TOWN OF ACTON
472 Main Street
Acton, Massachusetts, 01720
Telephone (978) 264-9628
Fax (978) 264-9630

INTERDEPARTMENTAL COMMUNICATION

Subject: Review of Renwick Way – 45 Main Street
Determination pursuant to Zoning Bylaw Section 1.3.16(4)

We have reviewed the above referenced Road Improvement Plan dated April 26, 2006 and we have the following comments relative to the requirements of the Town of Acton Subdivision Rules and Regulations:

Ty-in #45 MAIN ST. NEW 1" SERVICE OFF NEW 8" DE TO NEW 1" CURBSTOP

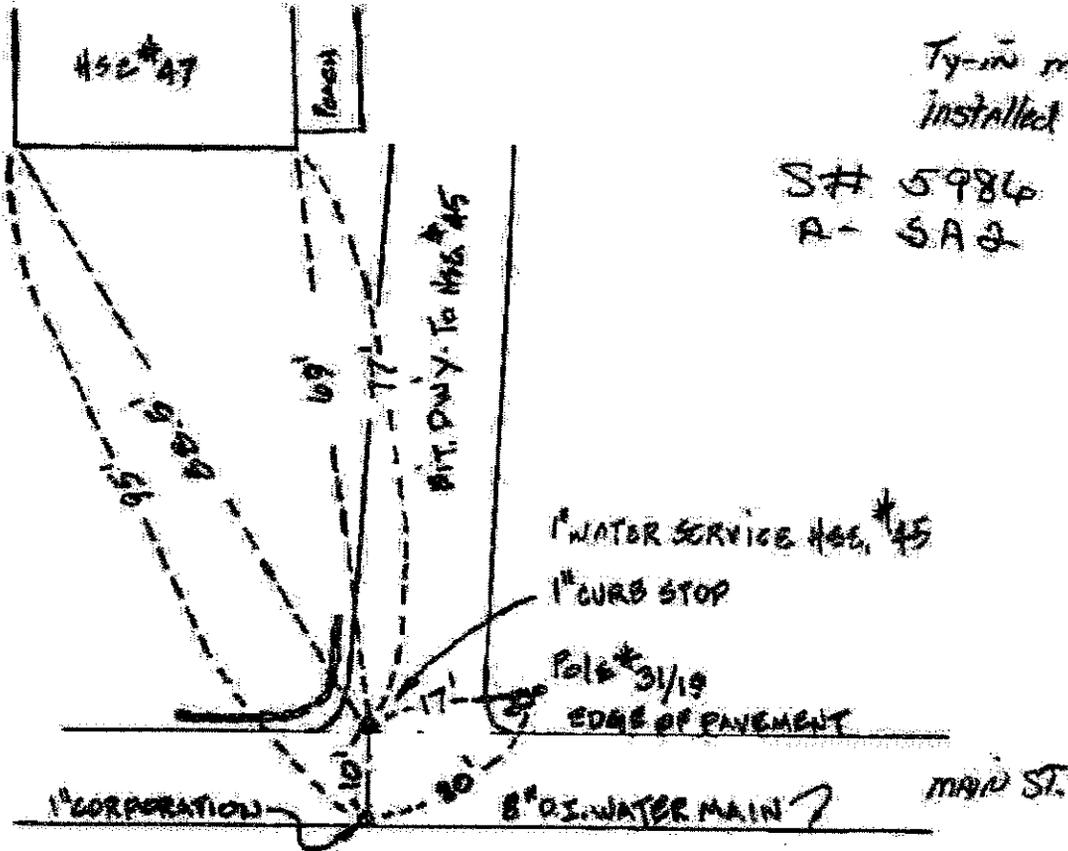
Review Comments: #45 Main St. is currently serviced by an existing 1" service line. It is not clear on the attached plan what is proposed for the new, and existing, properties on Renick Way?
